Subject: Puget Sound Power & Light Company
Skagit/Hanford Nuclear Project, Units 1 & 2
Docket Nos. 50-522 and 50-523
Application for Site Certification/Environmental Report
Amendment 6

Amendment 6 addresses the Washington State Energy Facility Site Evaluation Council Application Completeness Review, comments on the Draft Environmental Statement (NUREG-0894) and changes as a result of the NPDES hearing.

FIGURE 4.1-3

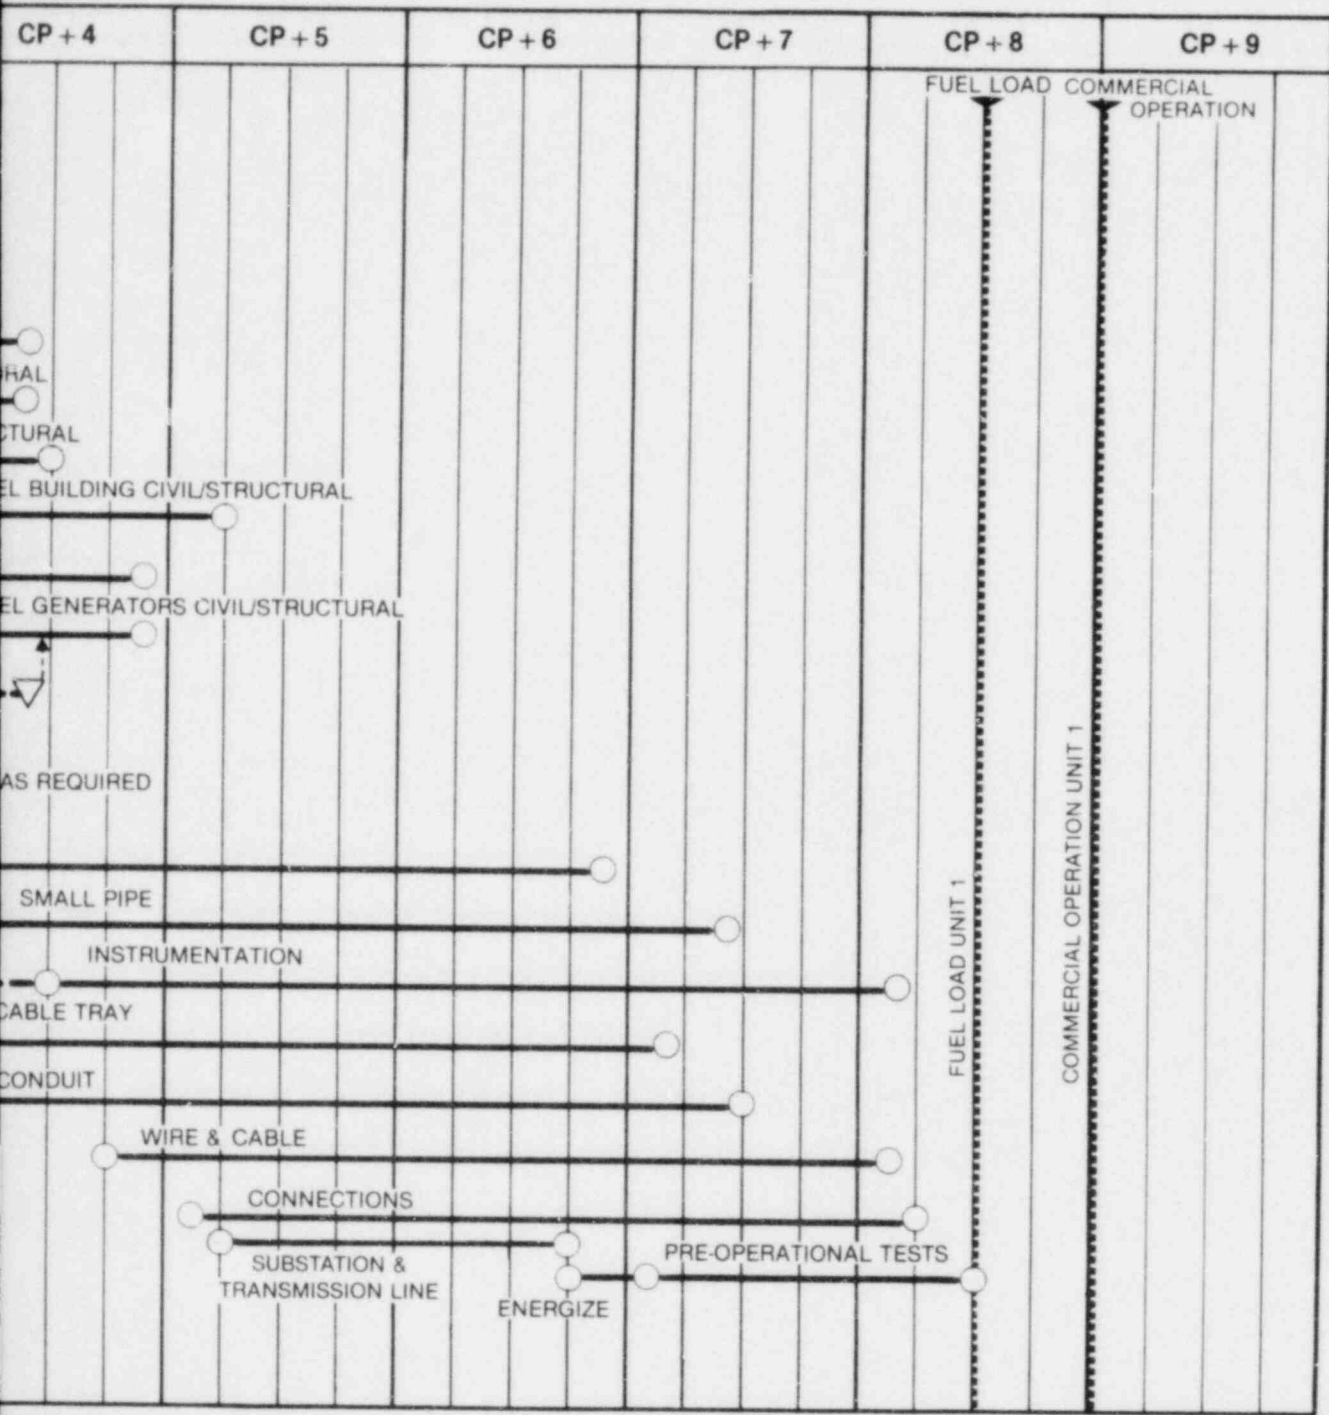
The construction schedule in Figure 4.1-3 is now out of date and should show construction and energization of the S/HNP transmission lines.

The construction schedule shown in Figure 4.1-3 is considered to be a typical construction schedule and representative of the types of construction activities and their anticipated schedules. Figure 4.1-3 has been revised to show construction and energization of the S/HNP transmission lines.

PUGET SOUND POWER & LIGHT COMPANY SKAGIT/HANFORD NUCLEAR PROJECT APPLICATION FOR SITE CERTIFICATION/ ENVIRONMENTAL REPORT
SURFACE ISOPLETHS CONCENTRATION FACTORS REGULATORY LIMITING CASE (1)
FIGURE 5.3-1

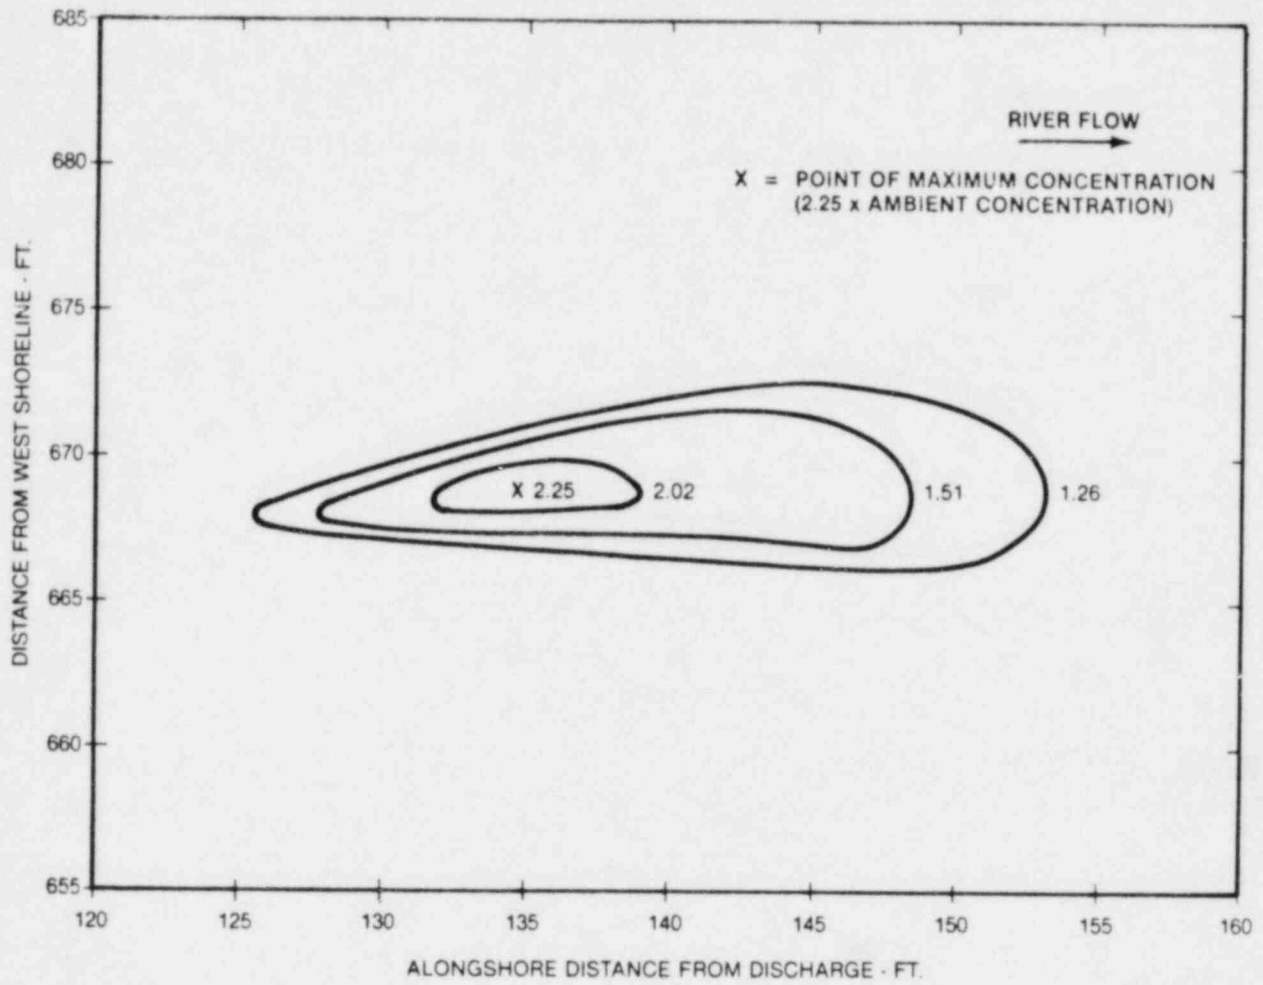
Provide contour maps showing proposed shoreline changes.	See revised Section 4.1.2.2.
Provide dilution isopleths.	See new Figures 5.3-1 through 5.3-4.
Provide detailed design specifications for the intake and discharge structure.	Final design has not been completed on the intake and discharge structures. Preliminary design information is presented in revised Section 4.1.2 of the ASC/ER and the figures referenced therein.
Provide a figure of the discharge nozzle.	See new Figure 4.1-9.

FIGURE 8.3-1

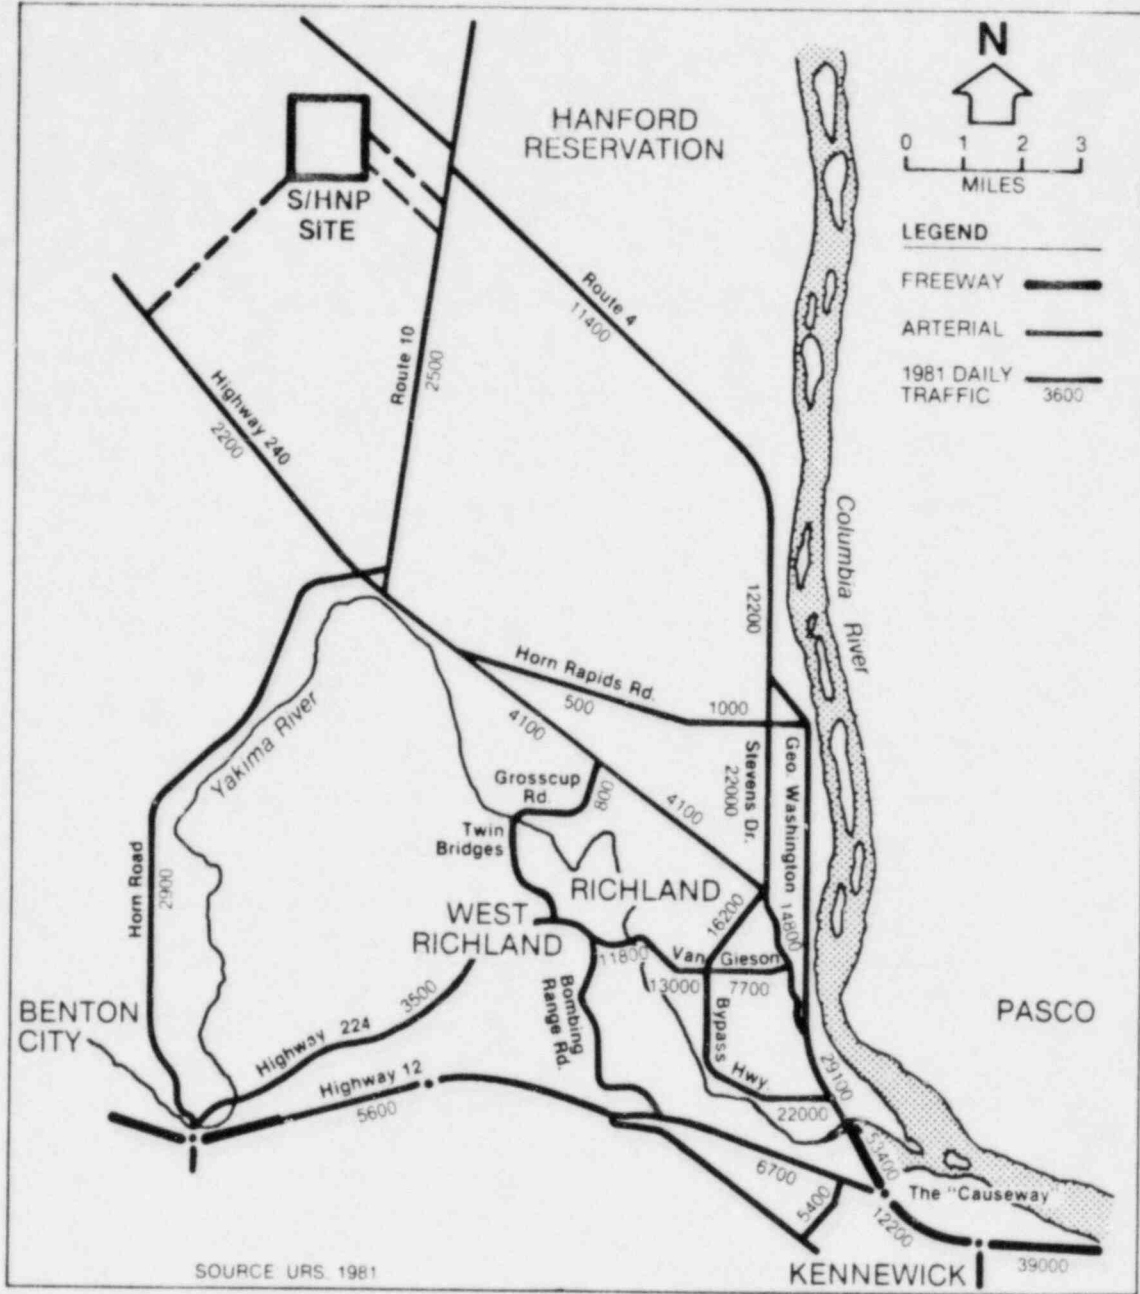
Figure 8.3-1 was cited in the text but was not provided.

The citation of Figure 8.3-1 was revised to Figure 2.1-1.
